October 29, 2014

**RE: DOCKET ID NO. EPA-HQ-OAR-2008-0218
COMMENTS ON PROPOSED REVISIONS TO 40 CFR PART 61 - SUBPART W,
NATIONAL EMISSION STANDARDS FOR RADON EMISSIONS FROM
OPERATING URANIUM MILL TAILINGS**

Figure 15: Radon Flux as a Function of Moisture Saturation and Moisture Content

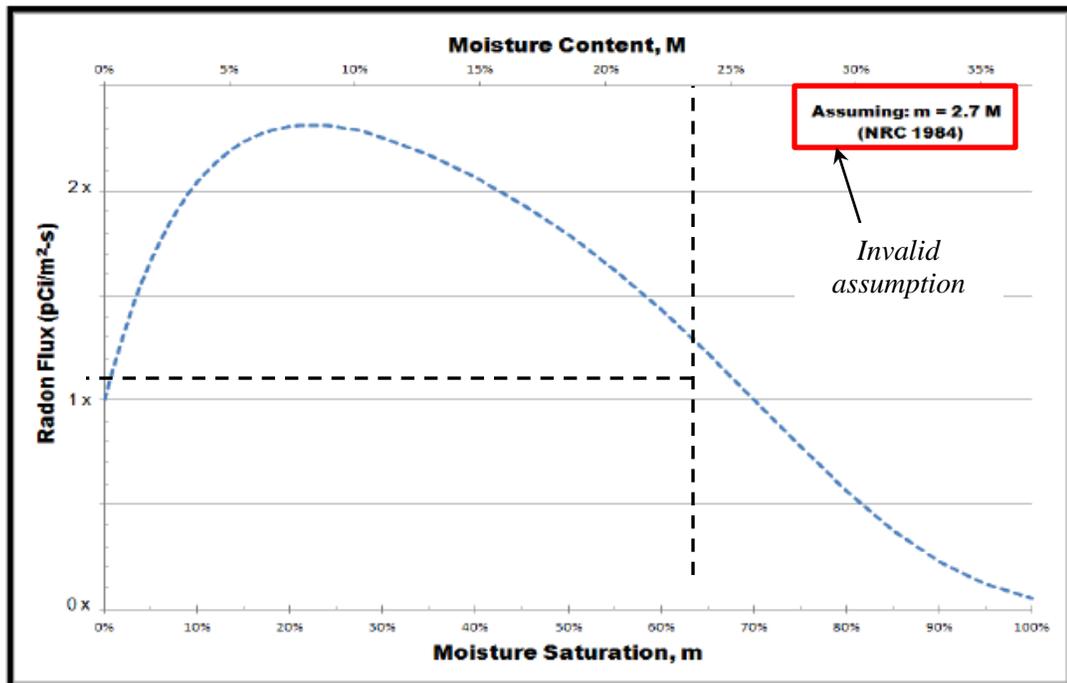
- Research presented by Rogers & Nielson (1991) and NRC (1984) show that above about 30% moisture saturation, the radon emanation coefficient is unchanged by increasing moisture, while the radon diffusion coefficient continues to decrease. The EPA used the Rogers & Nielson (1991) empirical relationship for the diffusion coefficient, combined with an assumed porosity of 0.39 and an approximation of the Vitro Sand emanation coefficient to calculate the total effect of moisture on the radon flux, shown below:

- Based on the above evaluation, the EPA indicates that a moisture saturation of 70% or greater is less than the flux at zero moisture, and that at a porosity of 0.39, the corresponding moisture

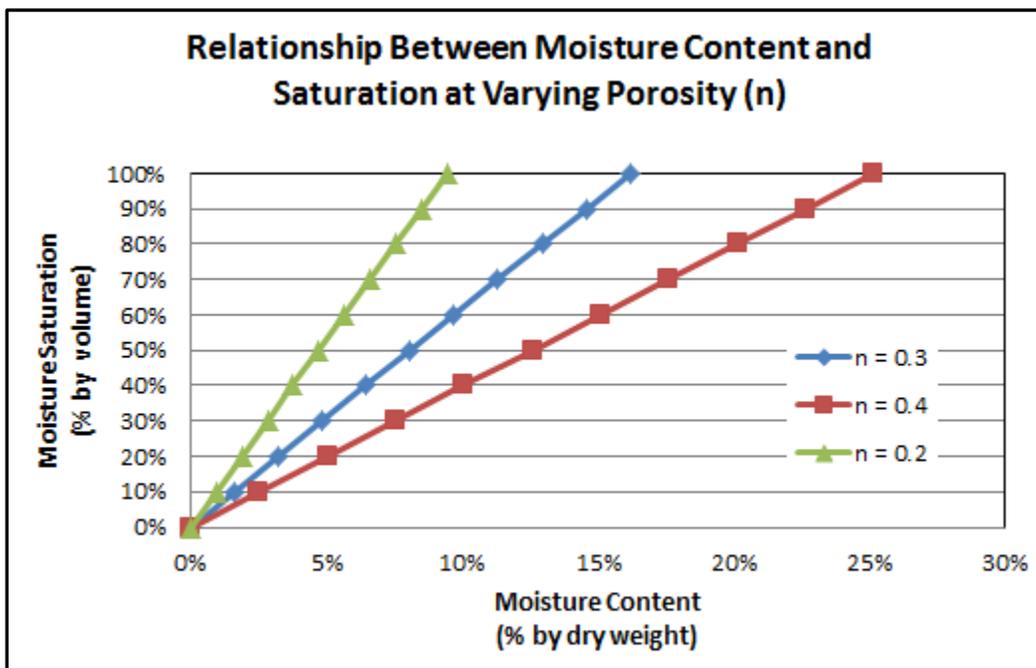
content (by weight) is 27%. Using this relationship, the EPA states that a moisture content of 30% by weight would therefore result in a radon flux significantly below the zero moisture flux. On the graph, the EPA references NRC (1984), noting that the moisture saturation (m) is assumed to be equal to 2.7 times the moisture content (M). This is an invalid assumption. For the example of the Vitro Sand presented, assuming a specific gravity of 2.65, the moisture content (by weight) at a moisture saturation (by pore volume) of 70% is actually only 17%. Similarly, a moisture content of 27% would correspond to a saturation on the order of 112%.

- Assuming a specific gravity of 2.65, Energy Fuels developed the following graph to illustrate how the moisture content (by weight) varies as a function of porosity (n) and as a function of saturation. At the typical range of expected ore porosities (i.e., 0.2 to 0.4), a moisture content of 30% exceeds 100% saturation, and hence represents a submerged condition:

Based on this analysis, Energy Fuels believes that the EPA’s approach to determination of a prescriptive 30% moisture content by weight is not appropriate. It should not be included as a standard in the Proposed Rules.
